STATE OF CALIFORNIA• DEPARTMENT OF TRANSPORTATION

POLICY DIRECTIVE

TRAFFIC OPERATIONS POLICY DIRECTIVE	NUMBER: 09-06	PAGE: 1 of 9
ROBERT COPP, DIVISION CHIEF (Signature)	DATE ISSUED: August 27,2009	EFFECTIVE DATE: September 10, 2009

Provide Bicycle and Motorcycle Detection on all new and modified approaches to traffic-actuated signals in the state of California.

Figure 4D-111(CA) Examples of Detection Systems (Sheet 1 of 3)

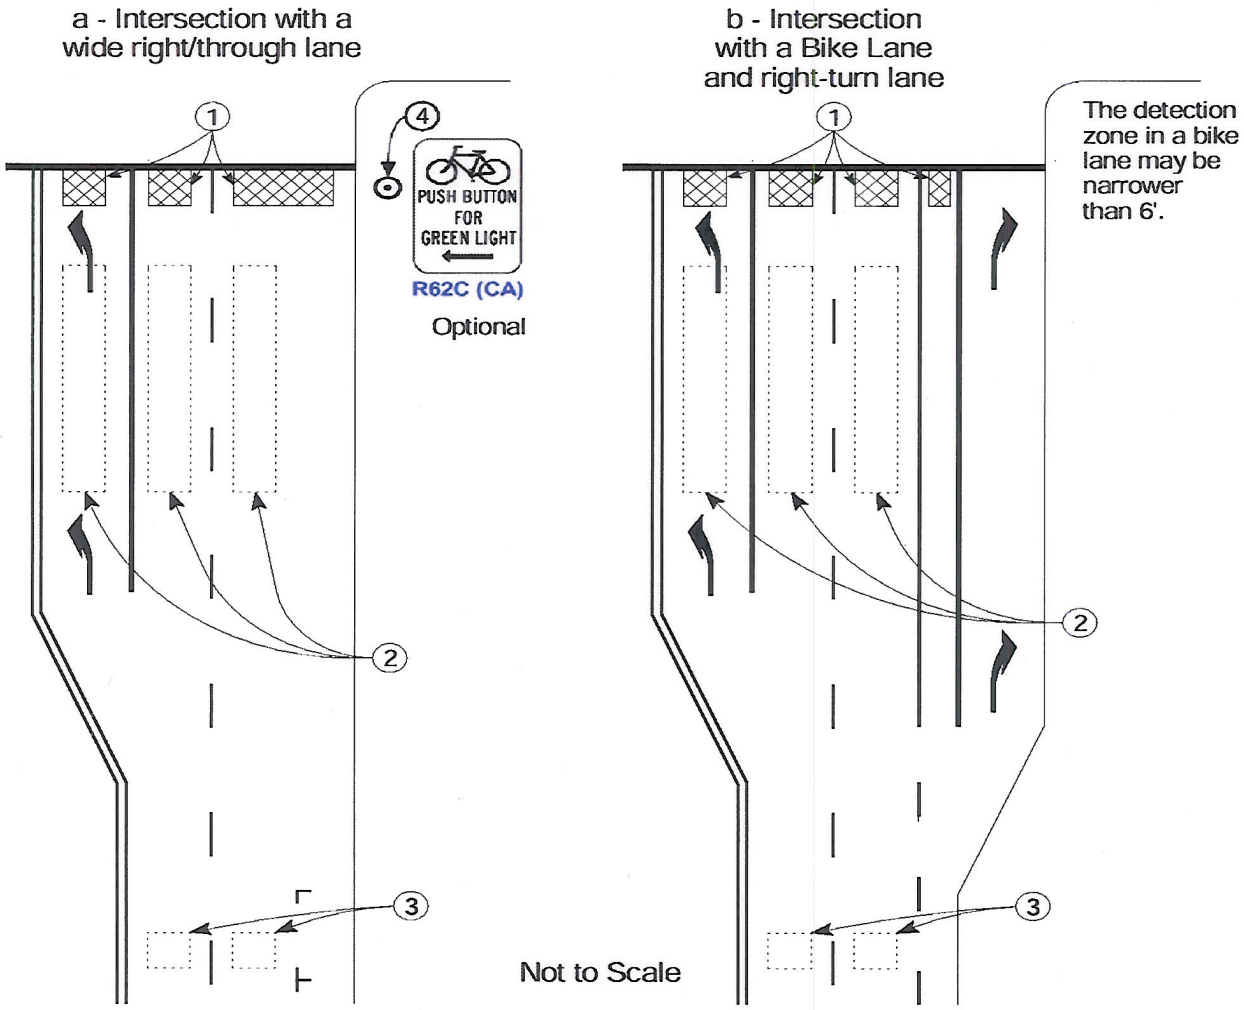
DOES THIS DIRECTIVE AFFECT OR SUPERSEDE ANOTHER DOCUMENT? ☒YES ☐NO	IF YES, DESCRIBE Amends Chapter 4D of the California MUTCD
WILL THIS DIRECTIVE BE INCORPORATED IN THE CALIFORNIA MANUAL ON UNIFORM TRAFFIC CONTROL DEVICES ☒YES ☐NO	IF YES, DESCRIBE Chapter 4D - Section 4D.105, Chapter 4A – Section 4A.02 (CA), Figure 4D-111 (CA) & add Table 4D-109 (CA)

Pursuant to the authority granted to the California Department of Transportation (Department) in Section 21400 and 21401 of the California Vehicle Code (CVC), Sections 4A.02, 4D.105 (CA) and Figure 4D-111 (CA) shall be revised and a new Table 4D-109 (CA) added to the California Manual on Uniform Traffic Control Devices (MUTCD) dated September 26, 2006 to provide Bicycle and Motorcycle Detection on all approaches to traffic-actuated signals in the State of California. This Directive is effective September 10, 2009.

1. Typical technology-neutral limit line detection locations. See Section 4D.105(CA).
2. Typical presence detection locations See Section 4D.103(CA).
3. Typical advance detection locations.
4. A bicyclist pushbutton may be used to activate a traffic signal to supplement the required limit line detection. A pushbutton should be located so it is convenient to use by bicyclists. See Section 9B.10 for bicycle regulatory signs.
